AGENDA OF THE LANDMARKS COMMISSION

WEDNESDAY, MAY 22, 2024, 4:30 PM
City Hall, Room 604 - The Harry Maier Room.
Virtual attendance is also available via Zoom.

Report to the
Landmarks Commission
of the City of Green Bay

PROPOSED EAST ELEVATION

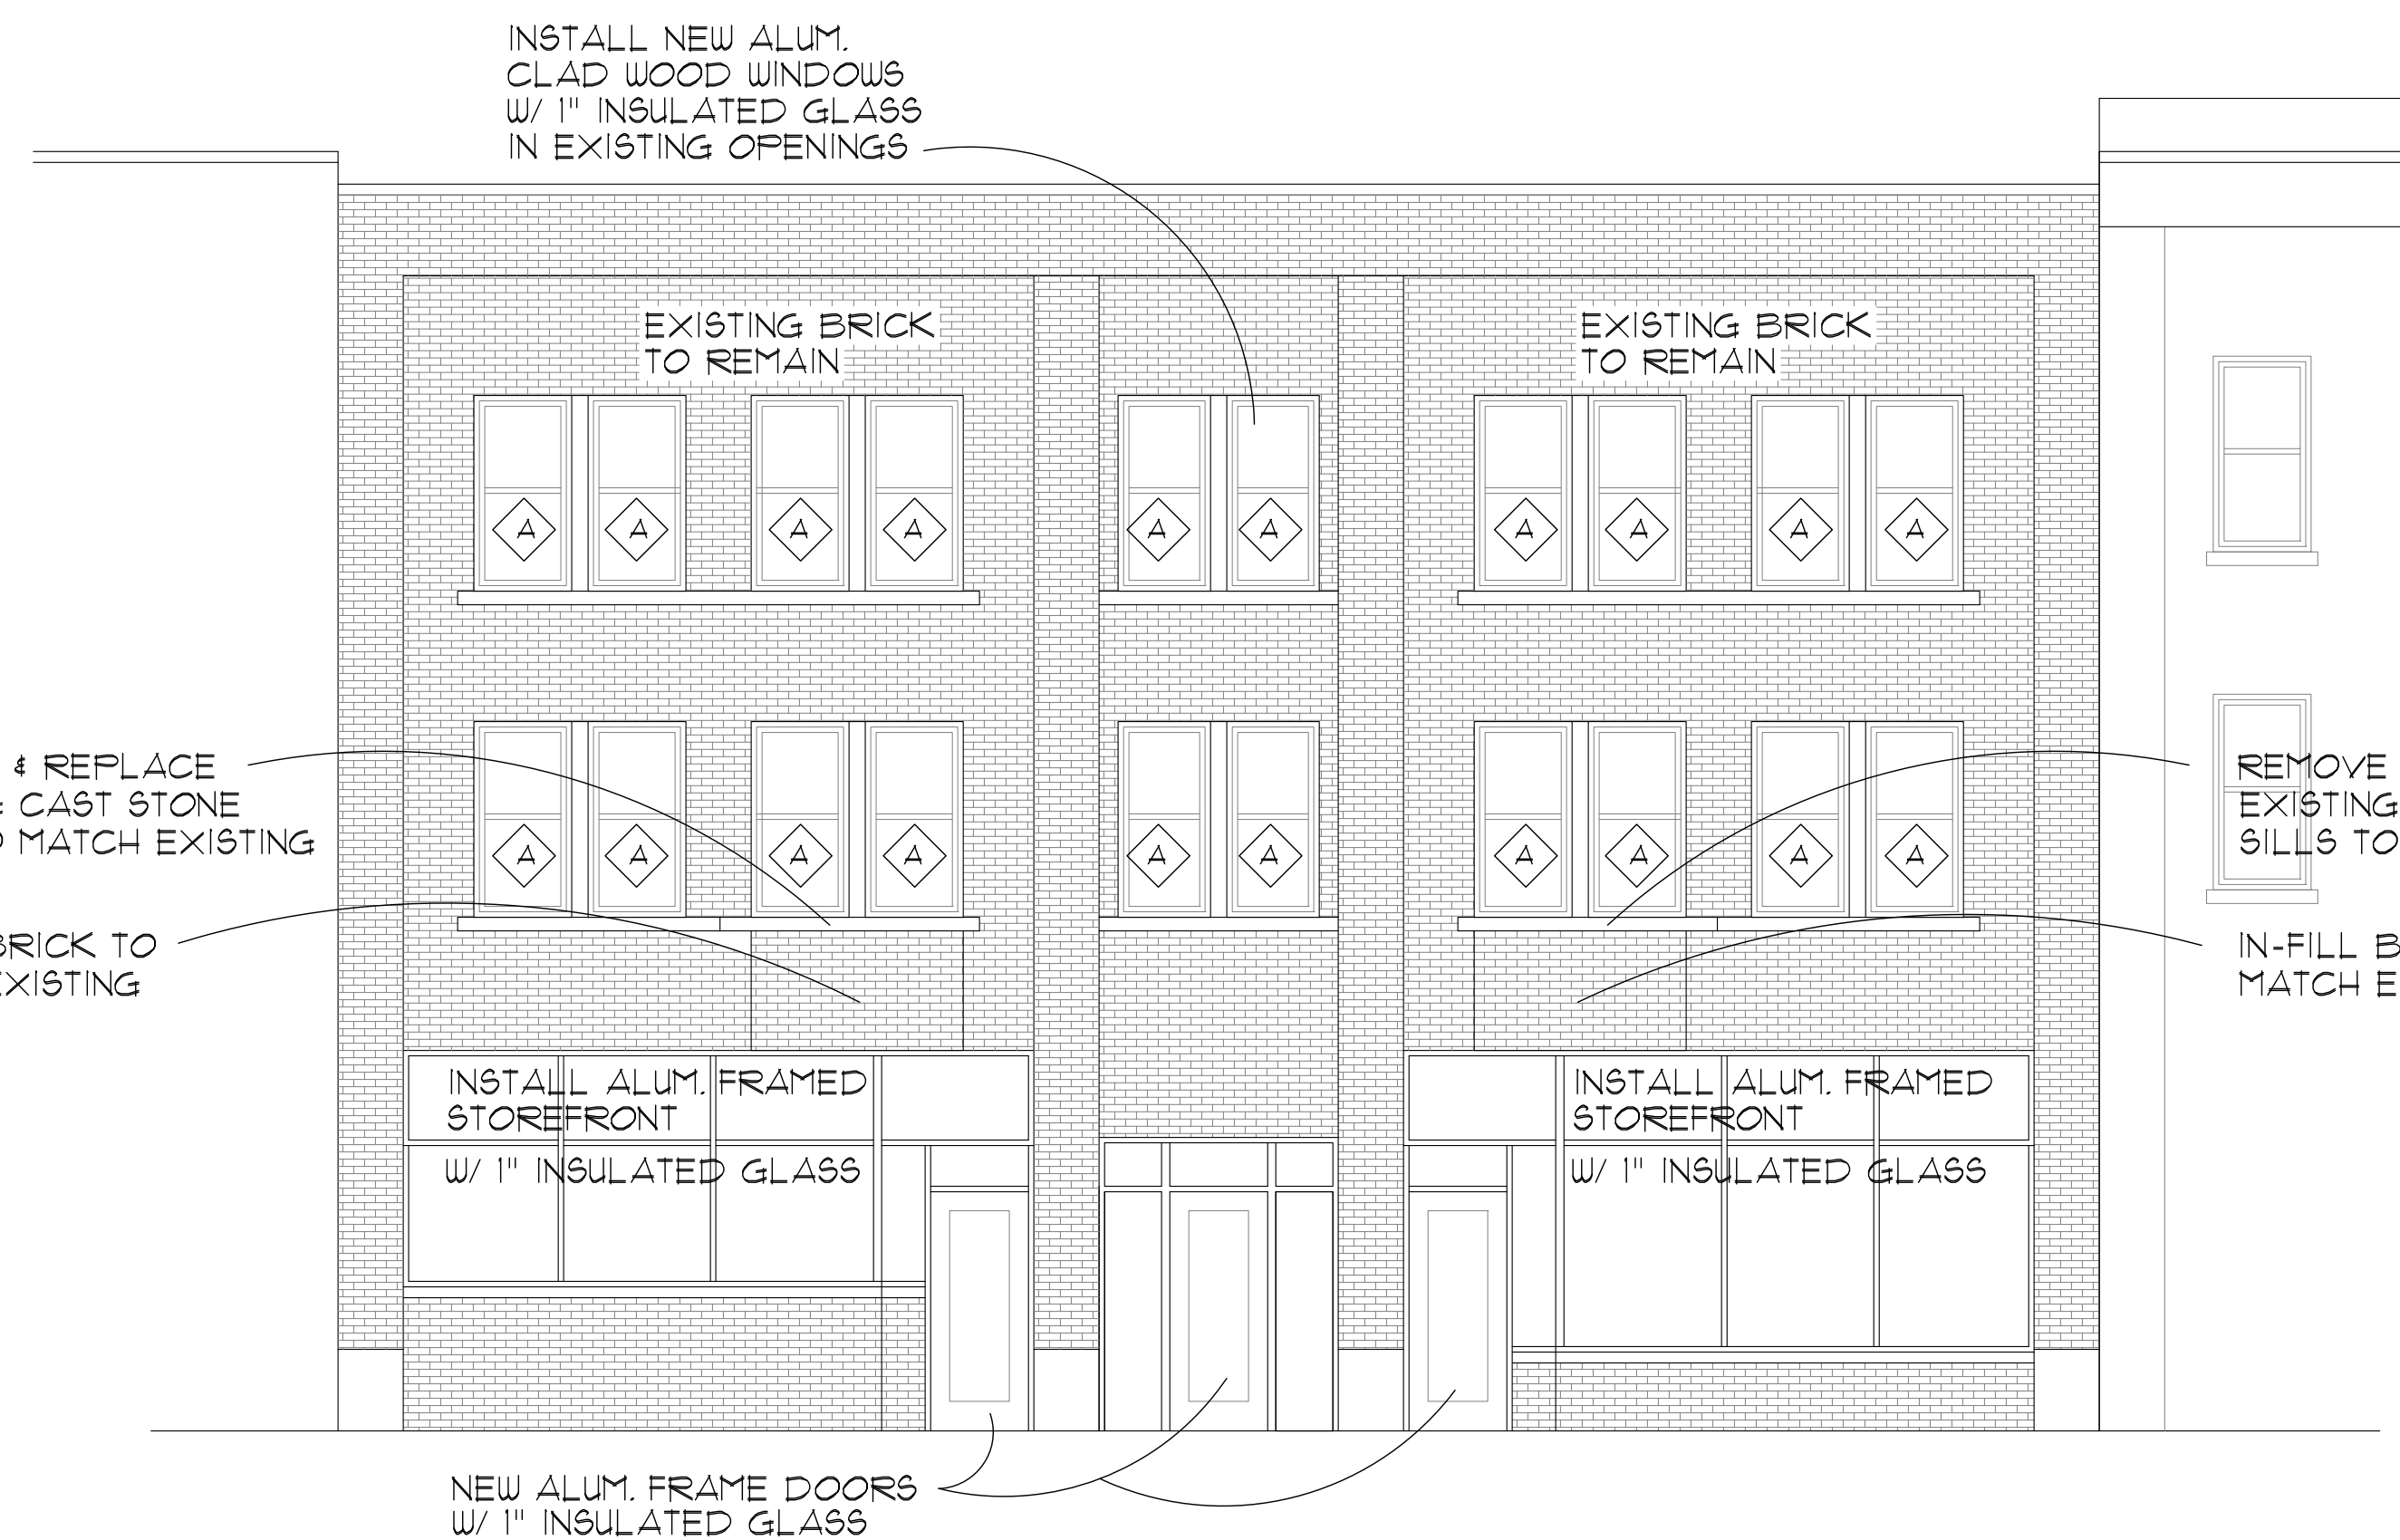
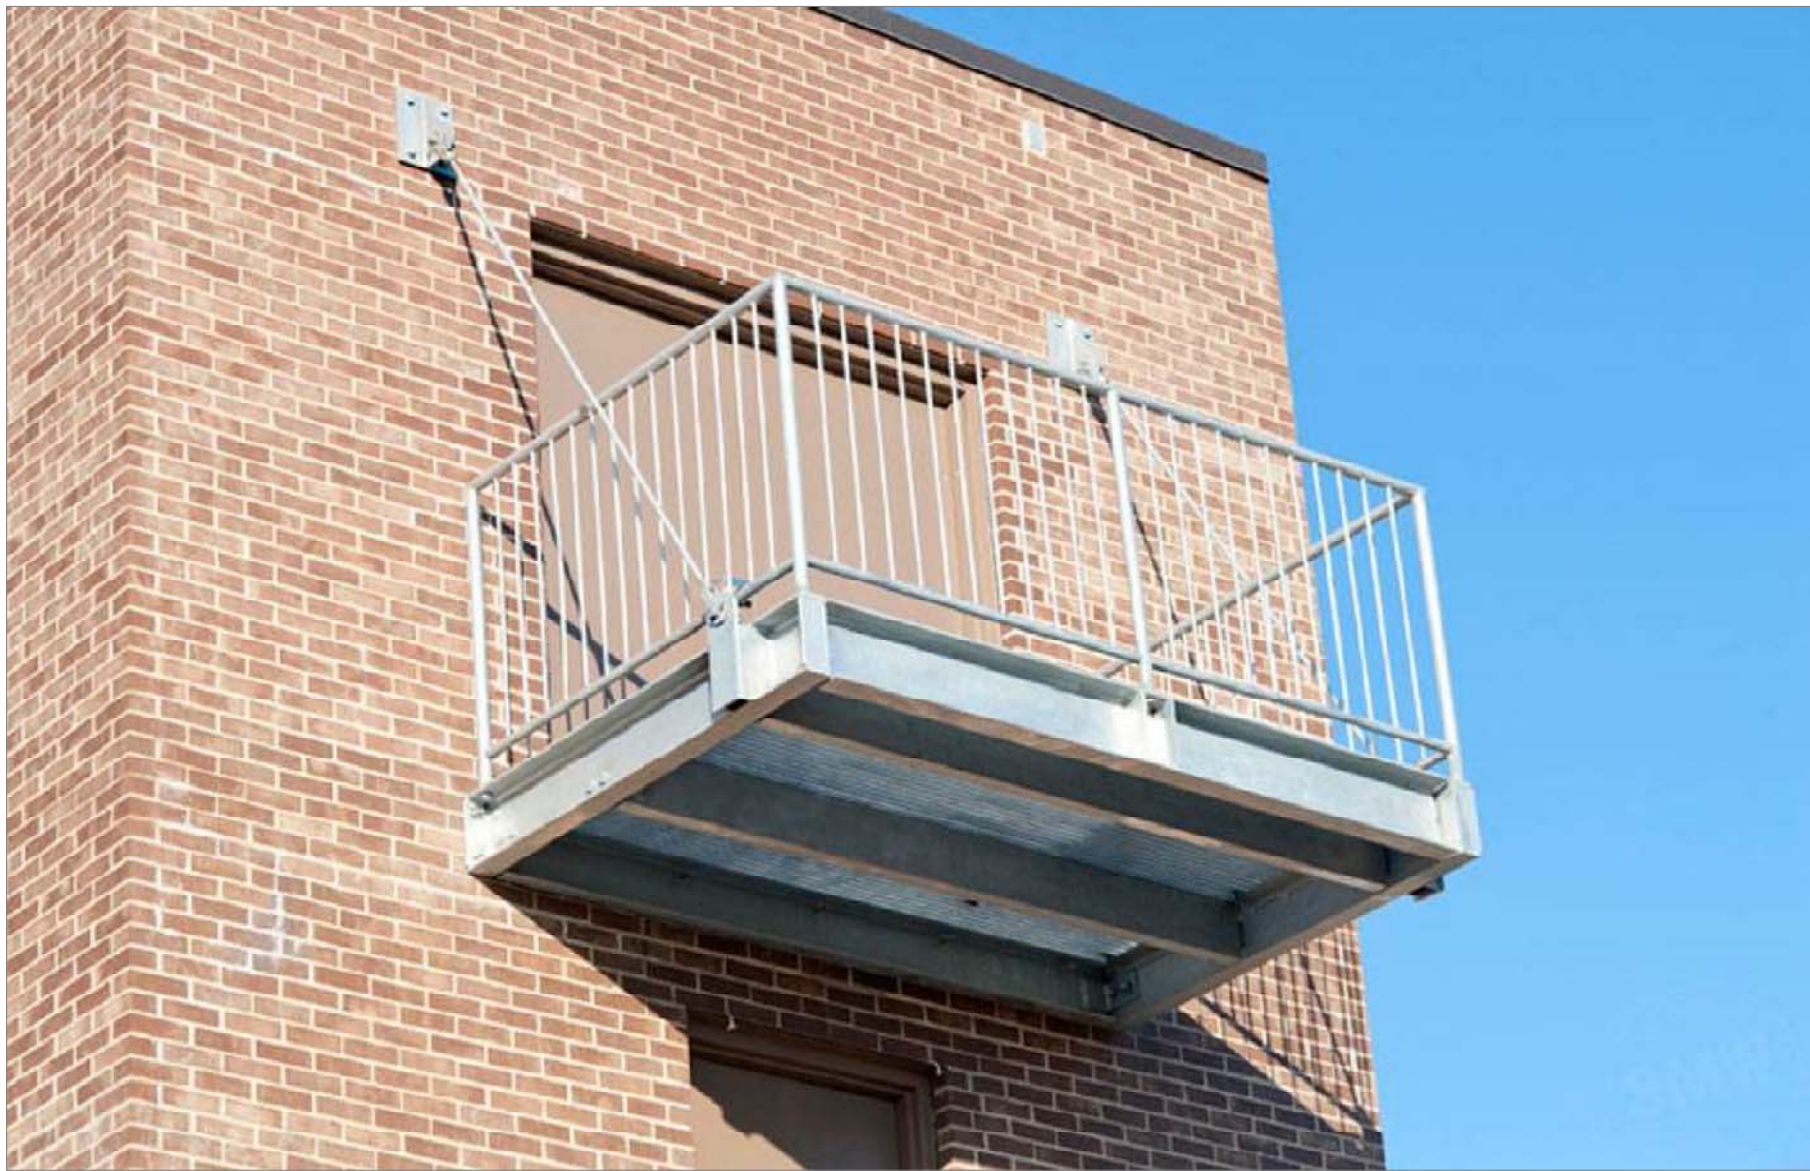
LC staff notes that the proposal to replace existing sash windows in the second and third stories and the proposal to replace the existing door surround in the first story are in conflict with SOI Standards 2, 5, and 6 as these materials were called out in the NRHP nomination as historic materials and features.

Regarding the storefront windows and the sash windows in the second and third stories, LC staff notes that the LC has generally taken a favorable view of replacement windows provided that the replacements match the design, dimensions, and appearance of the historic windows and provided that the window frames do not have an anodized finish. For commercial buildings in Green Bay, the Wisconsin SHPO requirement for a visual light transmittance value of 72 or higher has generally been upheld by the LC.

Regarding the first story door surround in the primary elevation, LC staff notes that the LC has generally required that historic material such as the square glass block transom (above the surround) be maintained rather than replaced. The door surround below this glass block transom has been identified as historic, but LC precedent on these elements is unclear.

LC staff feels that the proposed replacement windows (upper levels, storefront windows, and side storefront doors) are appropriate (presuming that the proposed dimensions match the existing openings) based on LC precedent provided that the replacements all have an appropriate visible light transmittance (VLT) and the aluminum frames do not have an anodized finish (must be painted or powdercoated). Generally, Wisconsin

LC staff recommends that the glass block transom above the existing front entry door be maintained. The existing glass block is a historic, character defining feature of the building.

LC staff feels that a replacement door surround (at center of first story) may be appropriate given the deteriorated condition of the wooden, paneled surround. No details of the proposed replacement surround have been provided, but LC staff recommends that the replacement satisfy SOI Standard # 6 insofar as design and visual qualities are concerned as well as SHPO requirements for glass visual light transmittance and finish on metal materials.

LC staff recommends that the removal of the second story doors on the front elevation be approved, along with their window substitution and brick infill to match the existing brick and existing brick design (the historic brick color, texture, and arrangement with decorative relief work and brick bond).
